STAFF RECOMMENDATION
1911 Boscobel Street
February 20, 2019

Metropolitan Historic Zoning Commission
Sunnyside in Sevier Park
3000 Granny White Pike
Nashville, Tennessee 37204
Telephone: (615) 862-7970
Fax: (615) 862-7974

Application: Demolition—Partial; New Construction—Addition
District: Lockeland Springs-East End Neighborhood Conservation Zoning Overlay
Council District: 06
Base Zoning: R6
Map and Parcel Number: 08314027500
Applicant: Kim Kennedy, Architect
Project Lead: Sean Alexander, sean.alexander@nashville.gov

Description of Project: The applicant proposes to demolish an existing rear addition and to construct a new addition to an historic house. The existing addition is wider than the existing house to the left, and the new addition will be wider to the left and right.

SITE PLAN

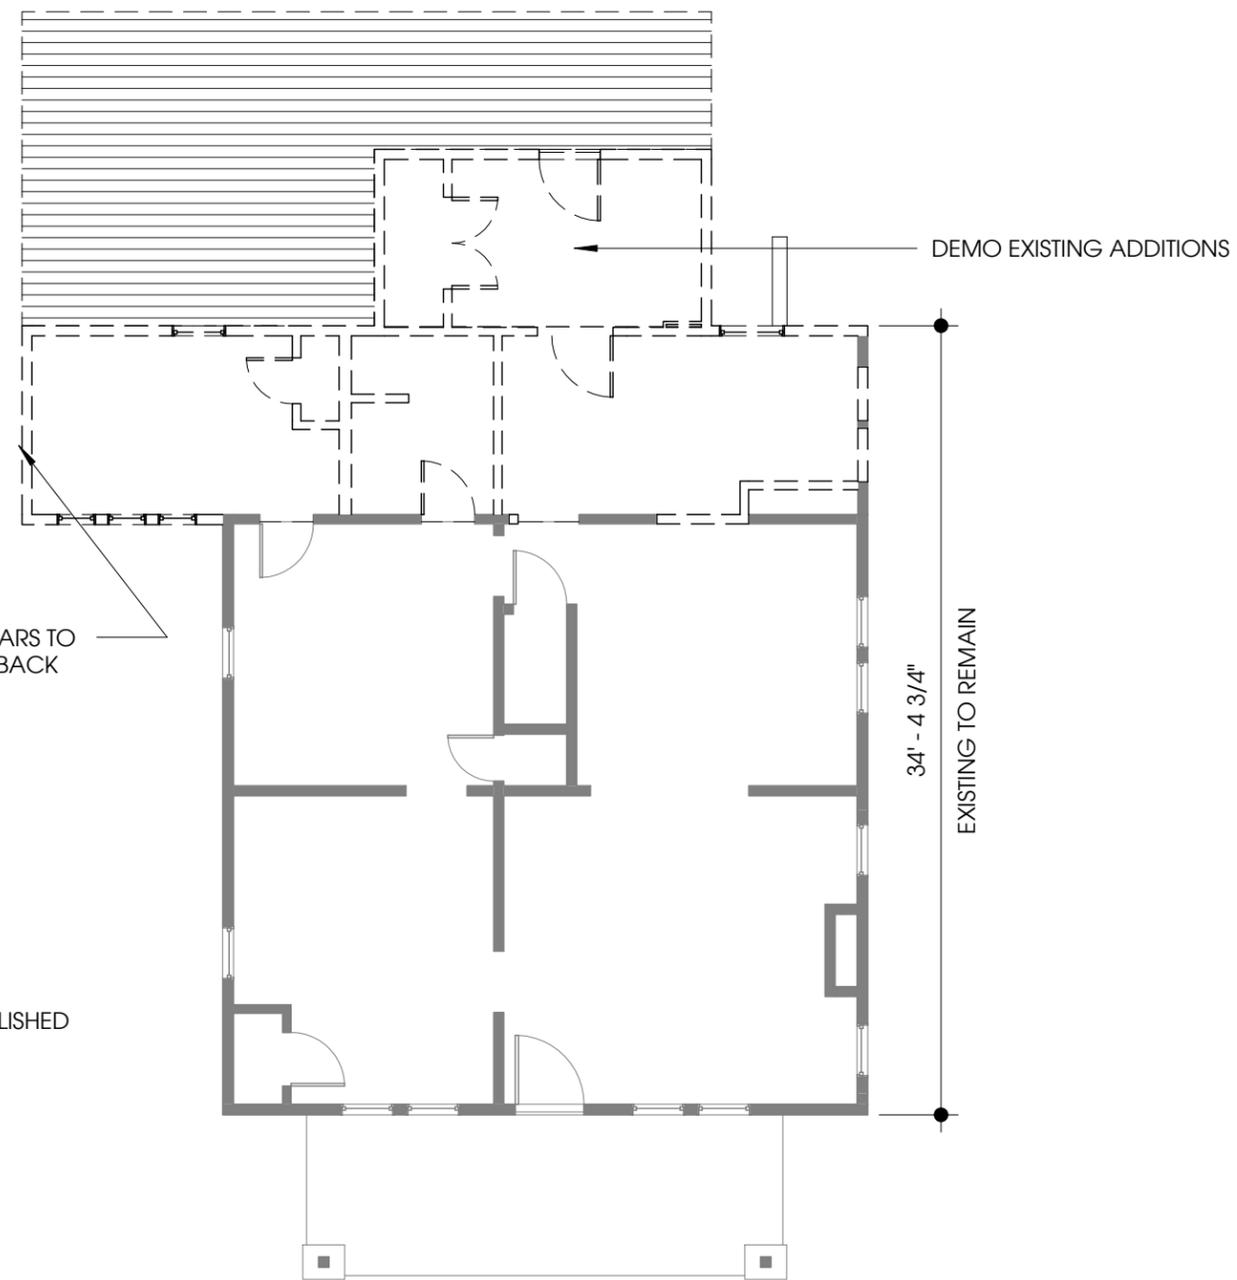
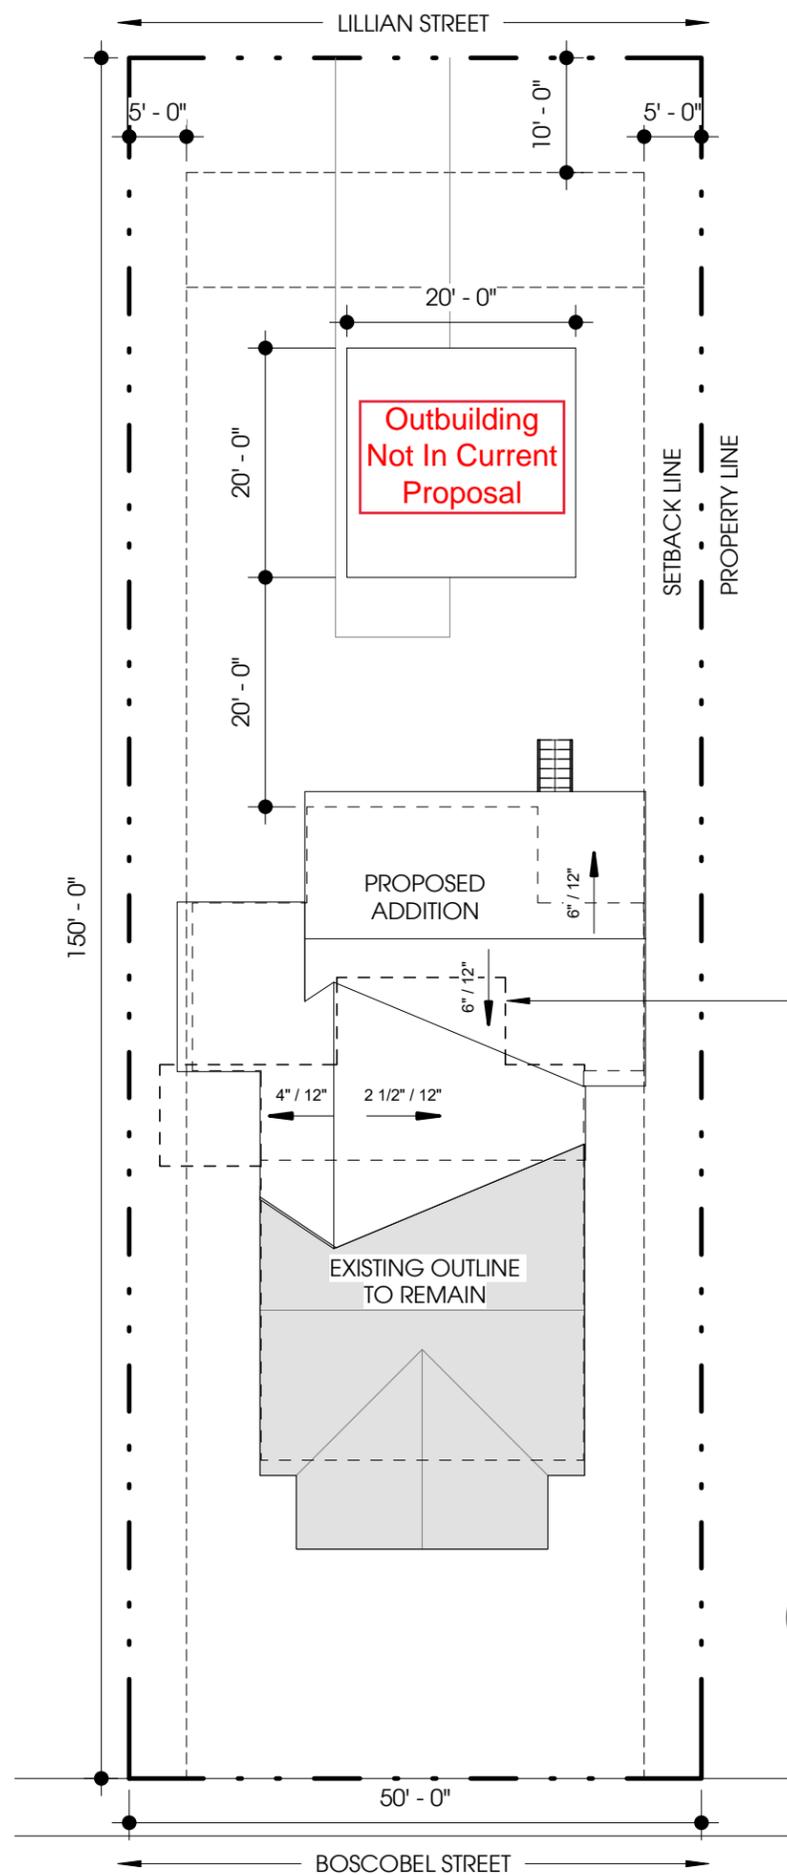
Location & Removability: The addition will attach to the existing house at the rear-left corner where the existing addition is being demolished, and at the right-rear corner. The addition will extend six feet (6') to the left side before going back fourteen feet (14') to the rear. The right side will extend five feet, three inches (5'-3") to the right before going back. Additions should generally be stepped in one foot (1') from each side of an historic house before going back; however staff finds the proposed addition going wider without stepping back to be appropriate because it replaces an existing addition that is not stepped in on the left side and because the addition is minimal and the existing house is small.

Setback & Rhythm of Spacing: The existing rear addition extends nine feet (9') to the left, encroaching approximately two feet (2') into the current required setback of five feet (5'). By reducing the width of the addition to the left with the new proposal, the new addition will meet the setback requirement and result in a more appropriate spacing between 1911 Boscobel Street and the house to the left. The addition to the right side will meet the five foot (5') setback. The adjacent building to the right is noncontributing. For these reasons, Staff finds that the setbacks for the proposed addition will meet section II.B.3 of the design guidelines.

Staff finds that the location and attachment of the addition to be appropriate and to meet sections II.B.2.a and II.B.2.d of the design guidelines.

FLOOR PLAN

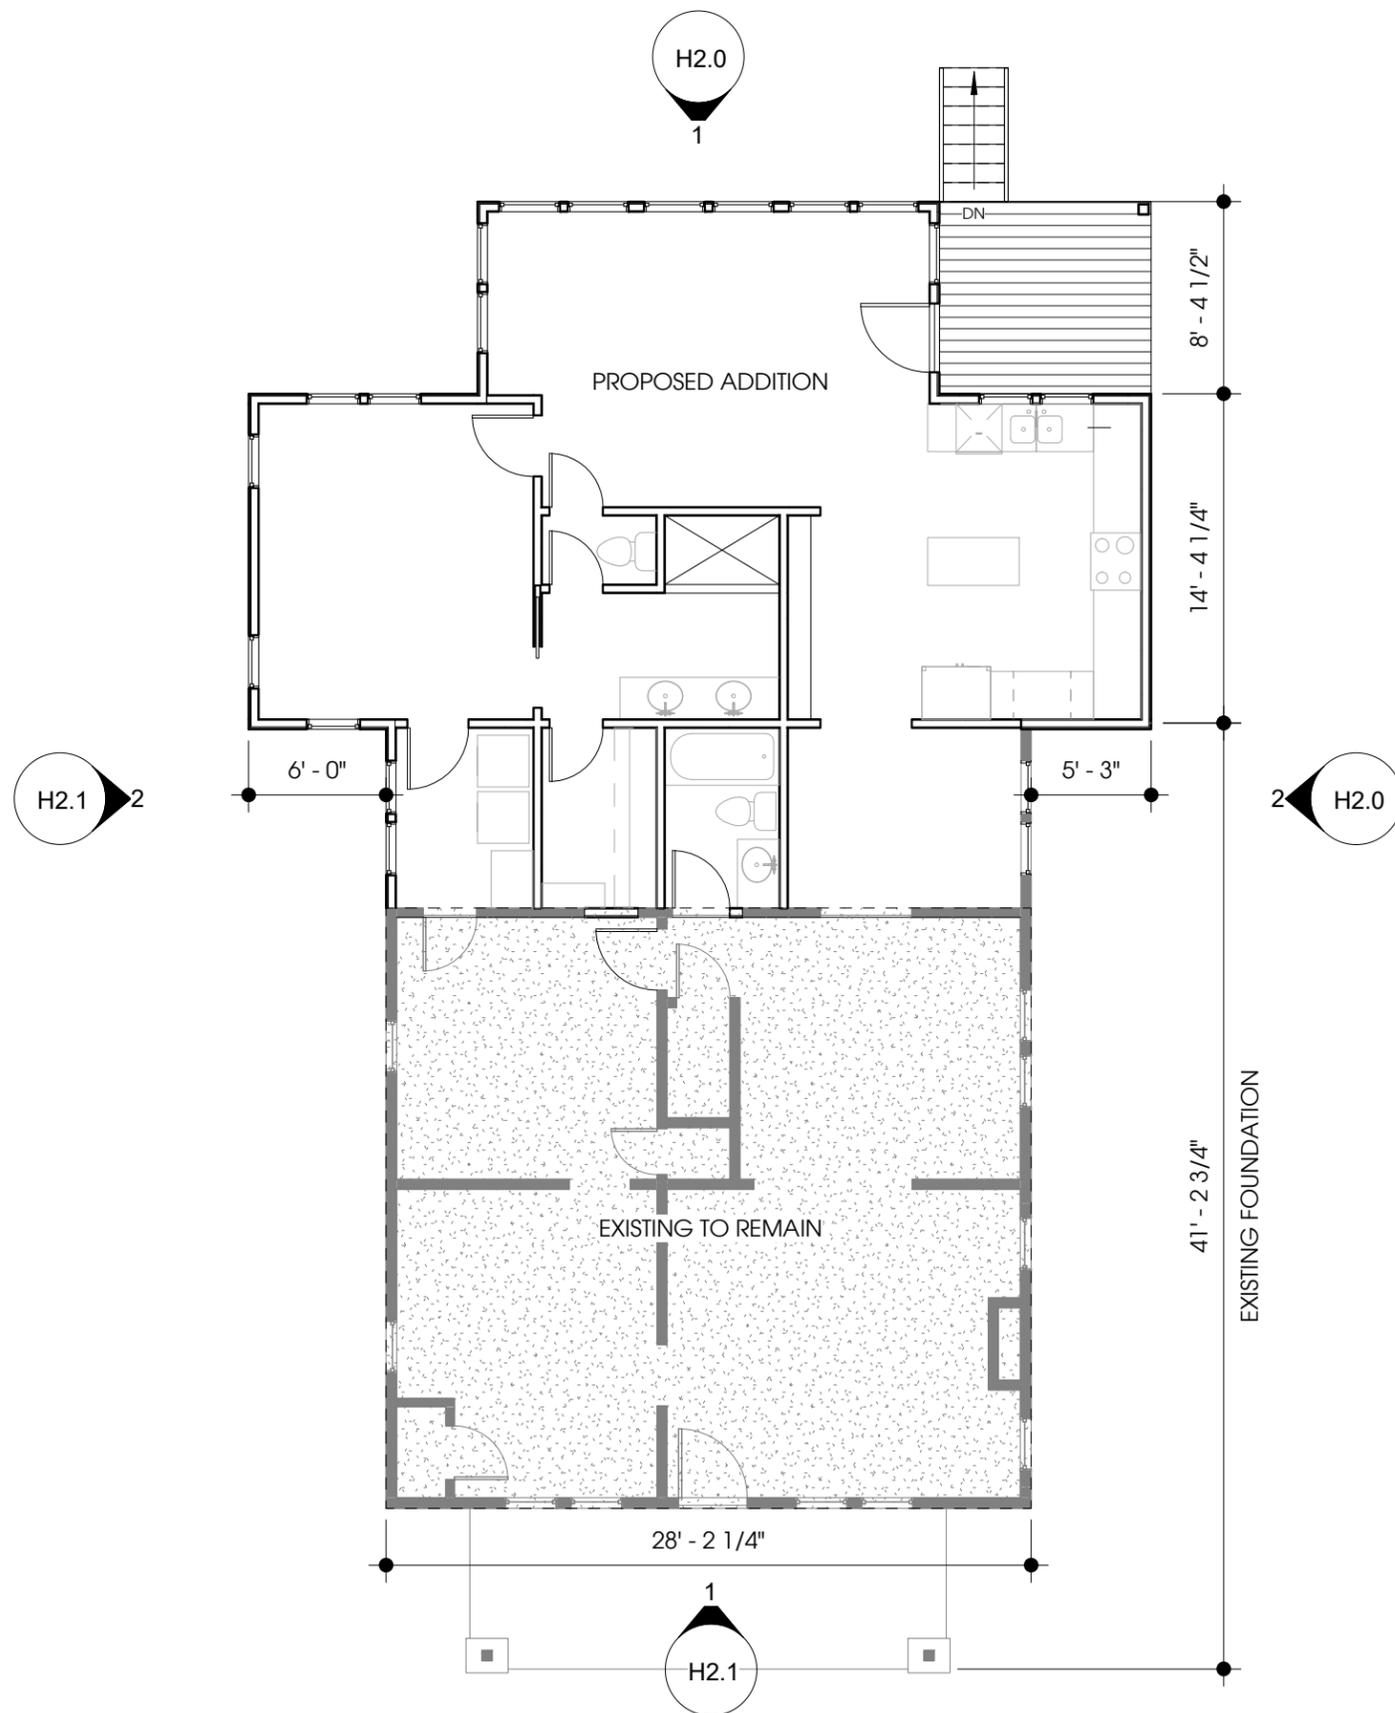
The addition increases the width of the house by five feet, three inches (5'-3") on the right but reduces the width on the left by three feet (3'). The total depth of the addition is twenty-three feet (23'), whereas the depth of the historic house is approximately forty-one feet (41'). Even with the additional width, the amount of new footprint being added is only half of the existing structure's footprint.

With a shorter roof height and footprint only half that of the existing house, Staff finds the scale of the proposed addition to be subordinate to the historic house and to meet sections II.B.1 and II.B.2 of the design guidelines.

ELEVATIONS

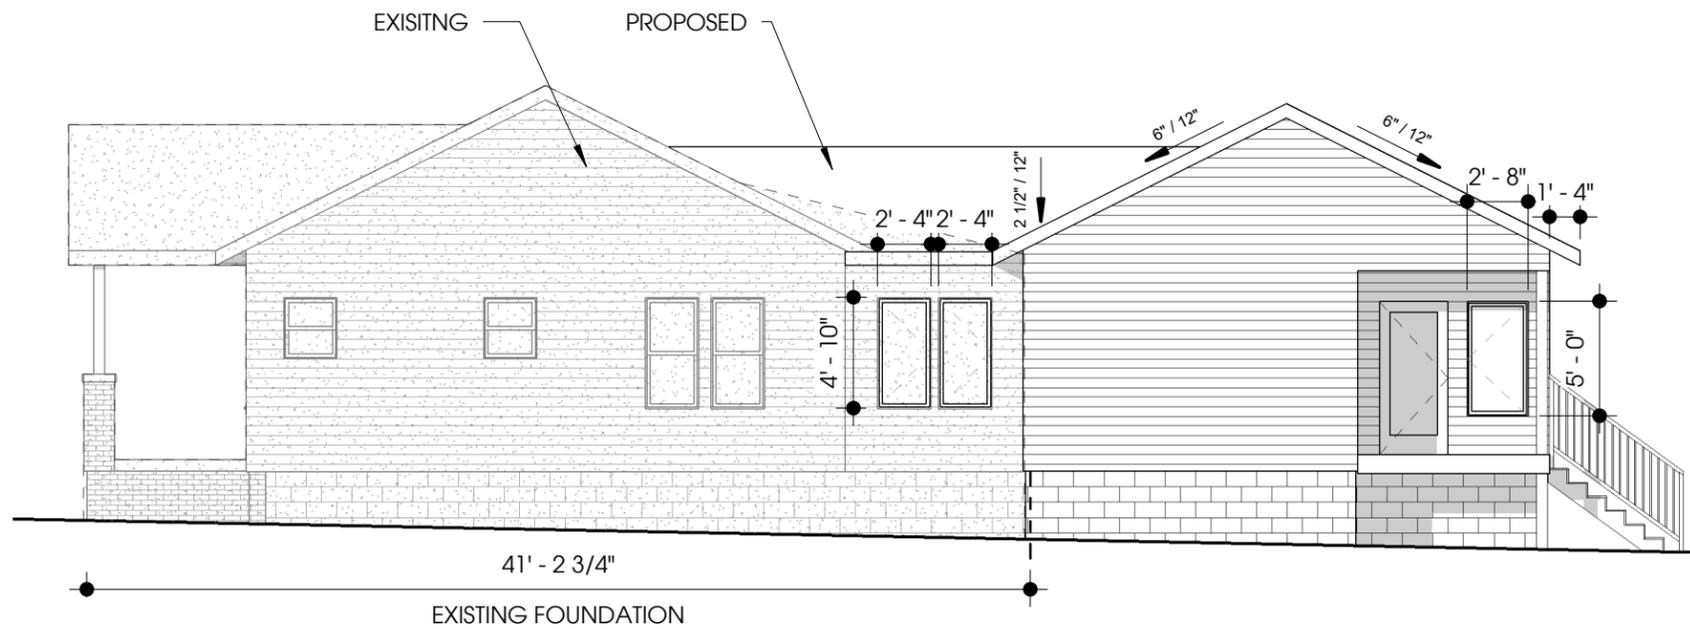
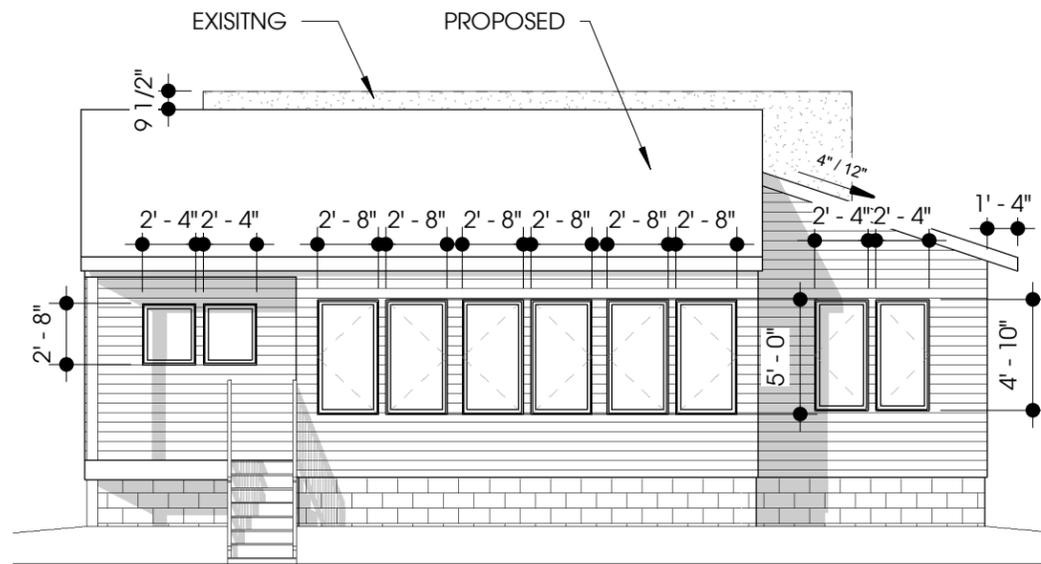
Height & Scale: The addition will have a side-gabled component at the rear, with a ridge height nine inches (9") shorter than the historic house's roof. A lower gabled hyphen will connect the new and existing gables by tying in two feet, nine inches (2'-9") below the existing ridge.

Roof form: The primary roof of the addition will be a side-oriented gable, matching the form and pitch of the existing roof. The roof on the left side addition will be a shed with a pitch of 4:12. These pitches are compatible with the historic house and meet section II.B.5 of the design guidelines.

Proportion and Rhythm of Openings: The window openings on the new addition will be vertically oriented openings, arranged in singles and pairs. The sizes and spaces between openings on the left side of the addition are consistent with the openings on the historic house. Staff finds that the window proportions and rhythms are generally compatible with the historic house and that the project will meet section II.B.7 of the design guidelines.

1. A window shall be added on the right side of the addition; and
2. The window selections and roof color shall be approved by MHZC Staff; and
3. The utility connections and HVAC units shall be located behind the midpoint of the building on a non-street facing façade.

Staff recommends that the window selections and roof colors are approved administratively to ensure that they are compatible with historic houses and meet section II.B.4 of the design guidelines.
